RE: DRAINAGE PLAN FOR LOT 1477, SANDIA HEIGHTS SOUTH
(D-23/D26) ENGINEER'S STAMP DATED JULY 15, 1992

DRAINAGE INFORMATION SHEET

PROJECT TITLE: DON MAESTAS RESIDENCE ZONE ATLAS/DRNG. FILE #: D-23 / D-26

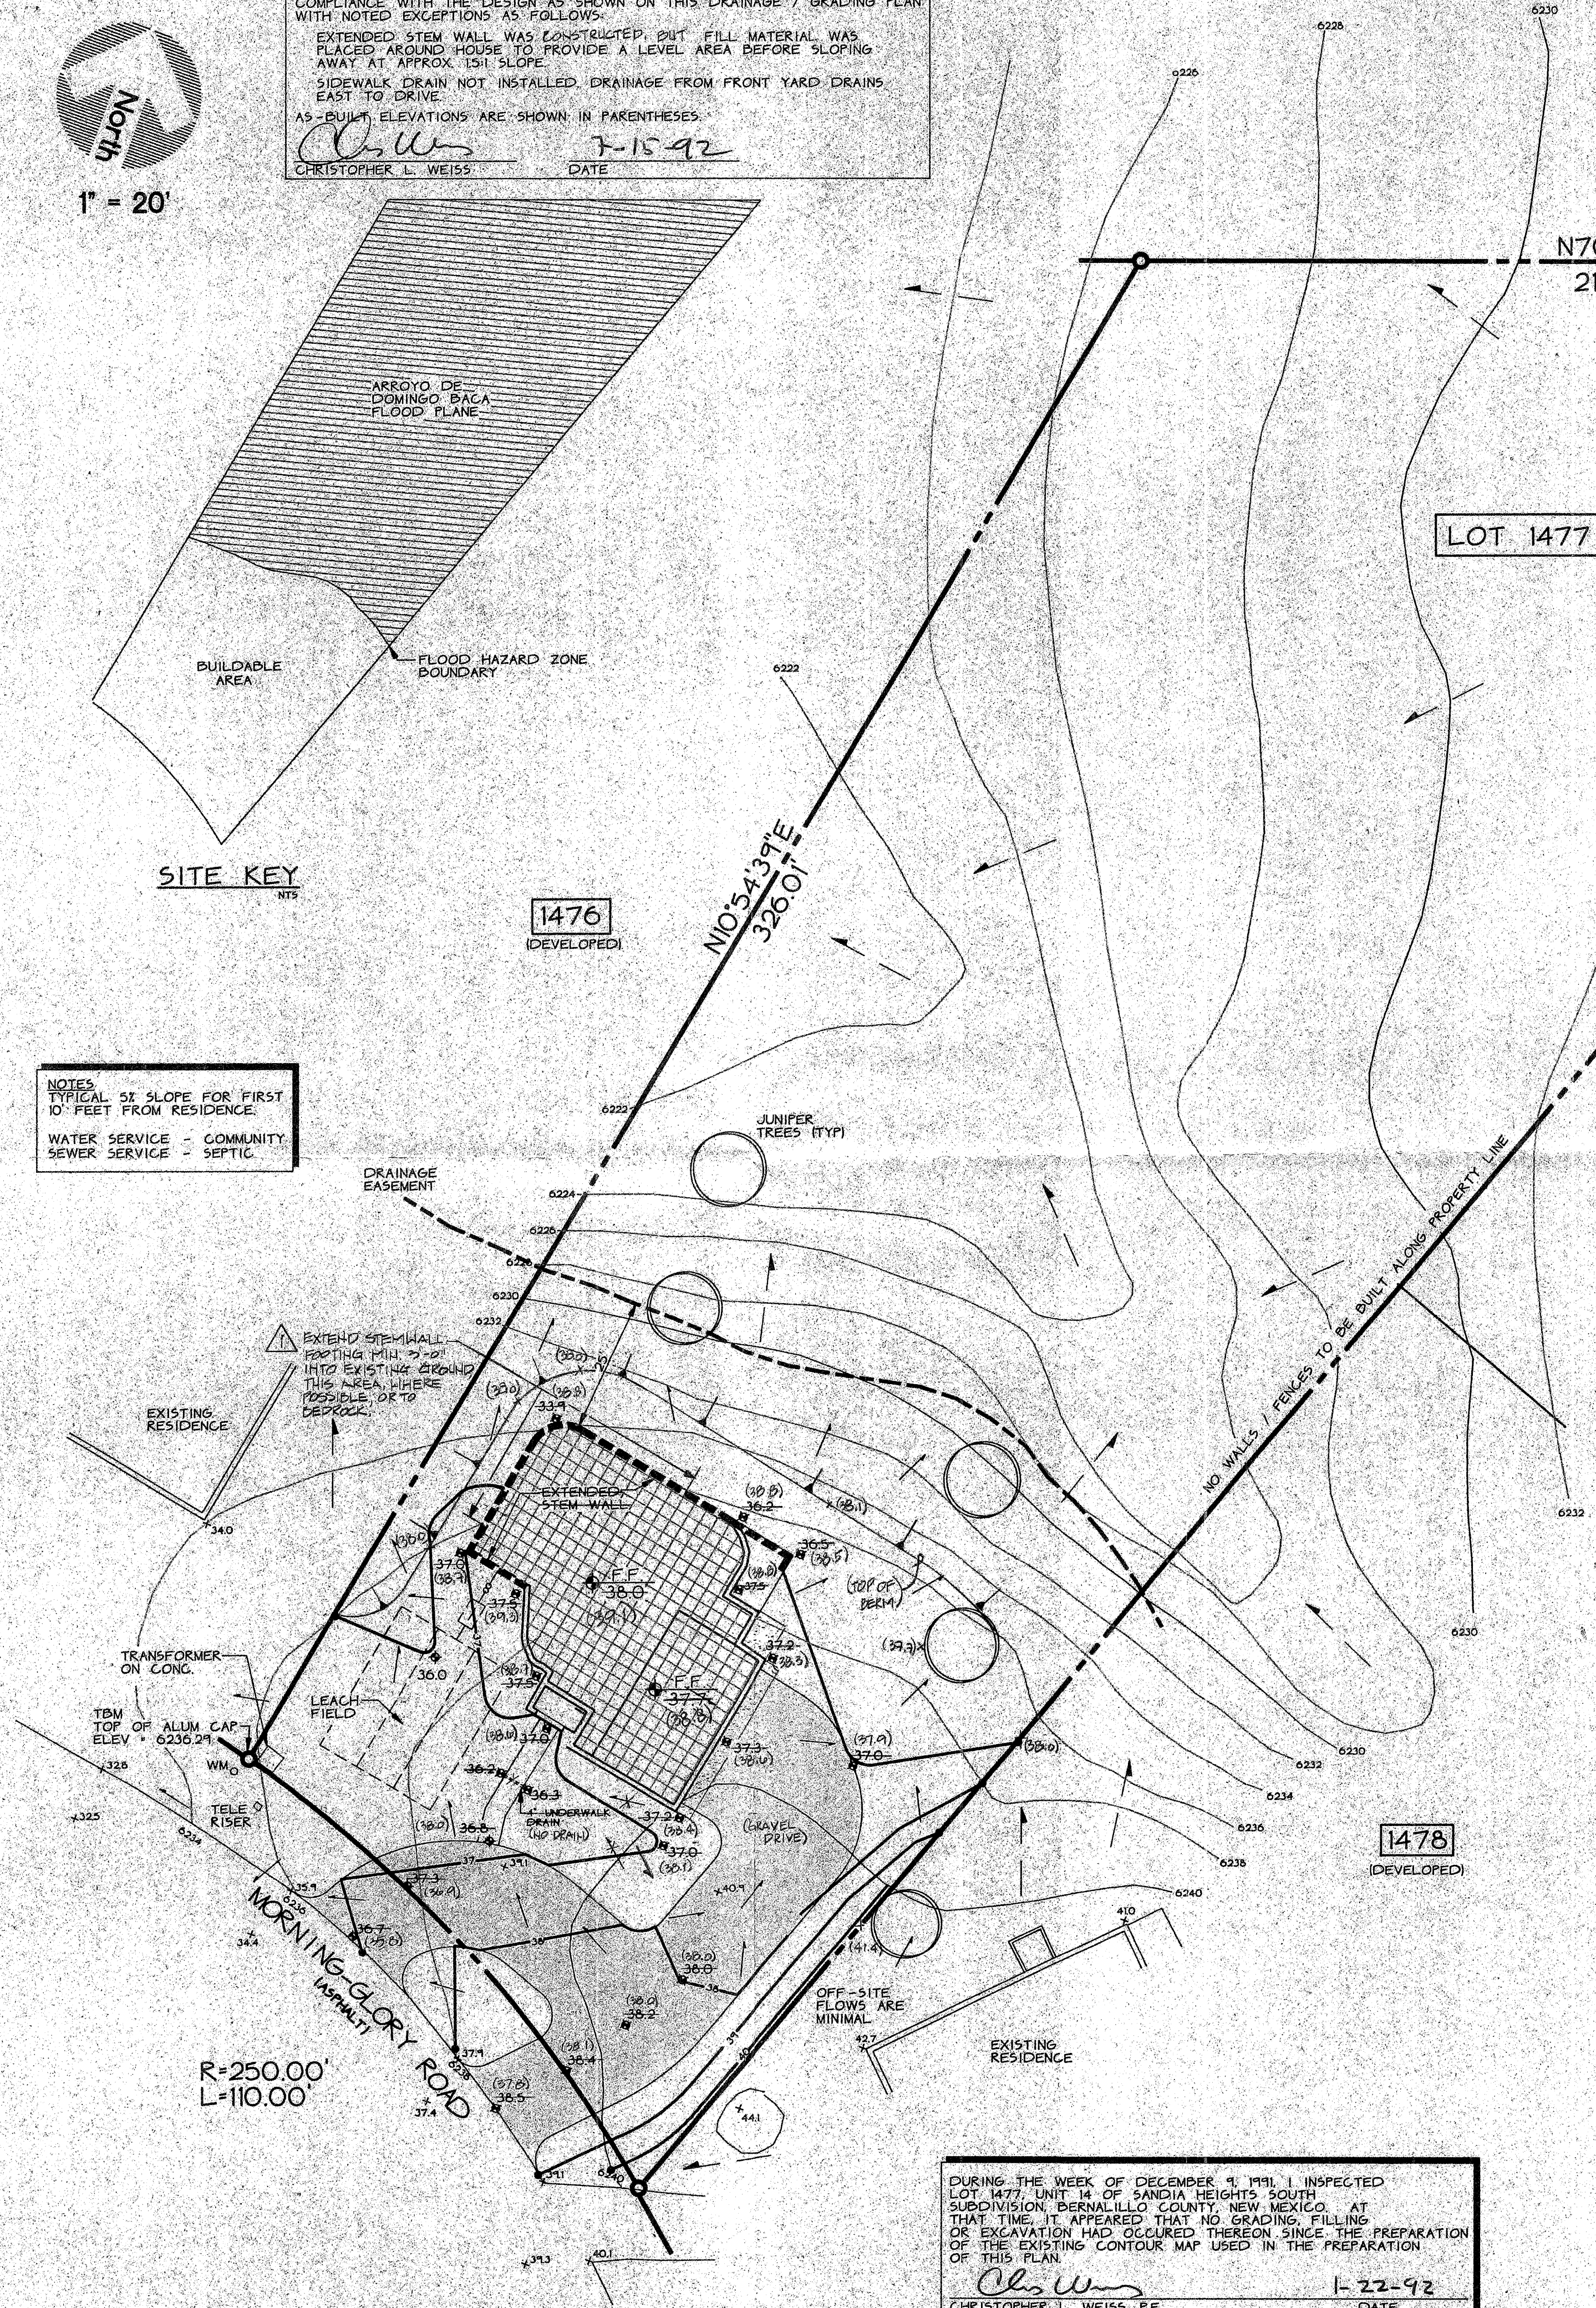
Based on the information provided, it appears additional fill material was placed along the edge of the floodplain. I want to caution you that in the future we will require additional analysis when this is done contrary to the approved plan. Be advised this additional fill material is susceptible to erosion, and the County and AMAFCA are not liable.

Otherwise, the plan is acceptable for the County Building Department to perform their final inspection.
